NEW MEXICO  
ENVIRONMENT DEPARTMENT

*Hazardous Waste Bureau*

March 31, 2011

**RE: LNAPL CONTAINMENT INTERIM MEASURE WORK PLAN  
BULK FUELS FACILITY SPILL  
KIRTLAND AIR FORCE BASE  
EPA ID# NM9570024423, HWB-KAFB-10-037**

Figure 1. Locations for Extraction Wells and Injection Well

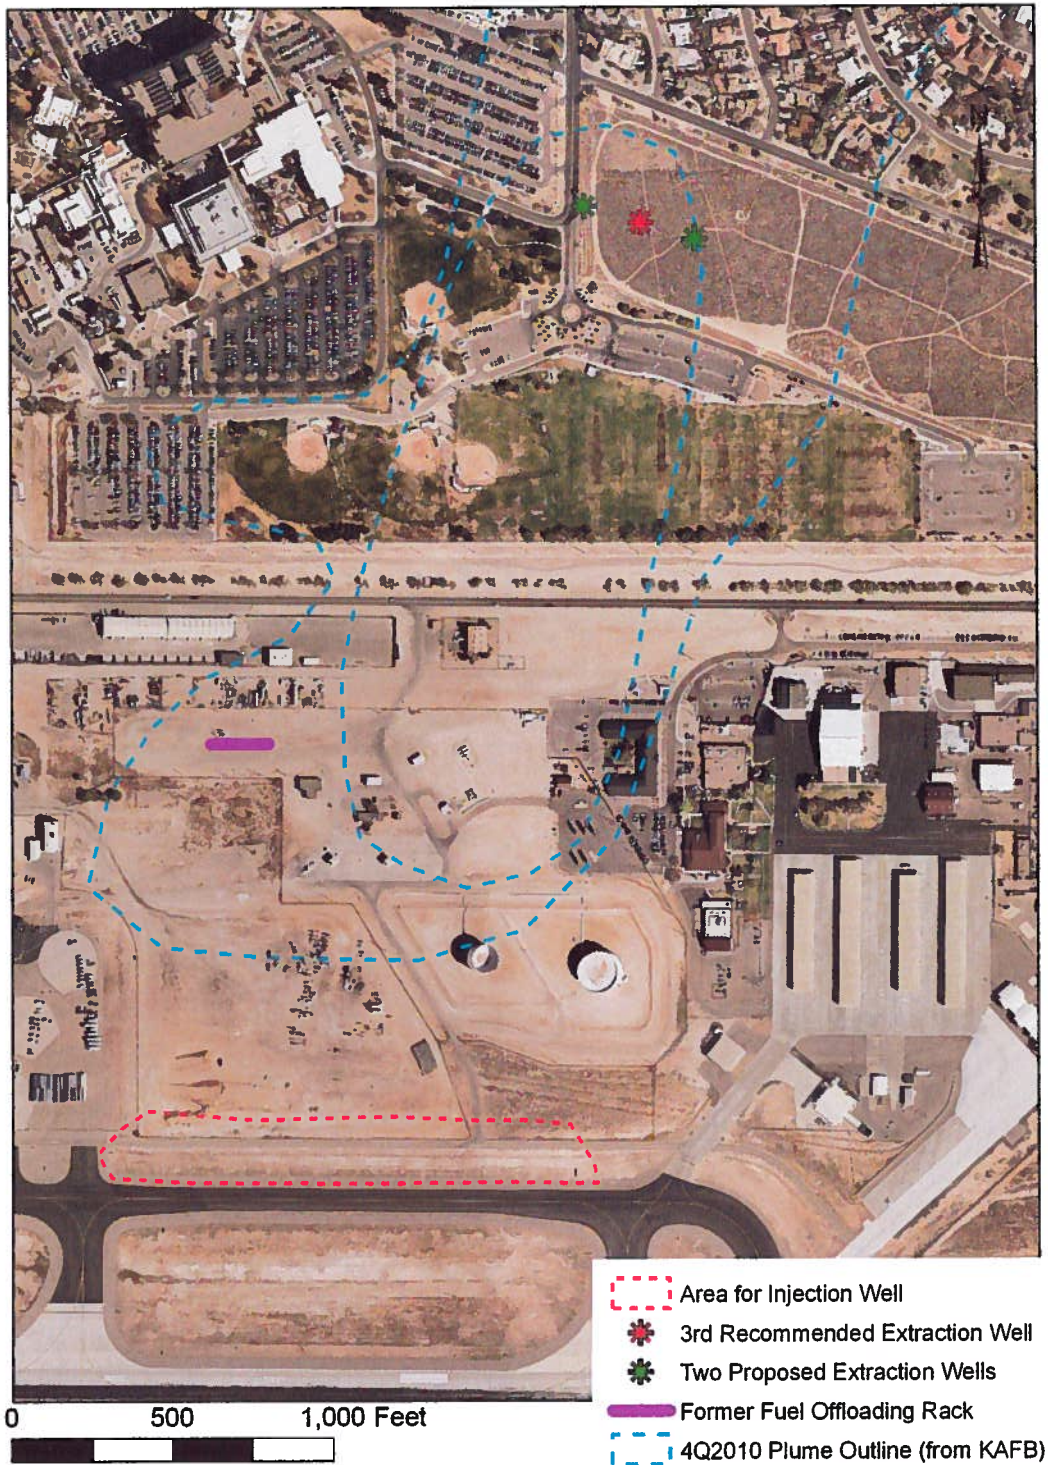
16. The Permittee's analysis indicates that two extraction wells will capture the LNAPL plume, assuming the hydraulic parameters used in the analysis are reasonably accurate. However, there is considerable uncertainty regarding these parameters. The last three bullets of Section 5.1 indicate that a feasibility analysis was performed that resulted in the selection of a two-well hydraulic extraction system. NMED agrees that a system with two vertical extraction wells is better than one vertical well for the reasons described. However, the same logic can be used to validate the efficiency of three vertical extraction wells or more. While the Permittee has demonstrated that one extraction well is inadequate, the optimum number is still in question. The proposed two-well system may in fact not provide adequate capture of the LNAPL plume. At least one additional extraction well should be considered to provide system redundancy, enhance system flexibility, and facilitate monitoring during system performance and pumping tests. The suggested location for the well is midway between proposed wells KAFB-106108-NAPL and KAFB-106109-NAPL (see Figure 1 of this letter).

This additional extraction well would provide additional benefits, including system back-up for the proposed primary extraction wells during down times, and (if not being pumped) water-level measurements within the capture zone between the active extraction wells. Even if not brought online immediately, it could be activated as a primary extraction in the future well to facilitate adequate capture.

17. NMED does not approve of a cross-gradient location of the injection well, as specified in Section 6.2 and as shown on Figures 5-1, 5-2, and 6-1 of the Work Plan. This objection was first expressed by the NMED in its public meeting held on January 12, 2011, where representatives of KAFB were present. The injection well must be located upgradient of the LNAPL plume within the area shown on Figure 1 of this letter such that any contaminated water for which treatment fails to achieve clean up goals will be recaptured by the containment system or other future remedial system. The proposed injection well location is not acceptable because detectable levels of contaminants would be introduced into a portion of the aquifer near a water supply well where contamination is not known to exist. Also, this area would not be subject to capture and subsequent treatment, putting the water supply unnecessarily at risk.
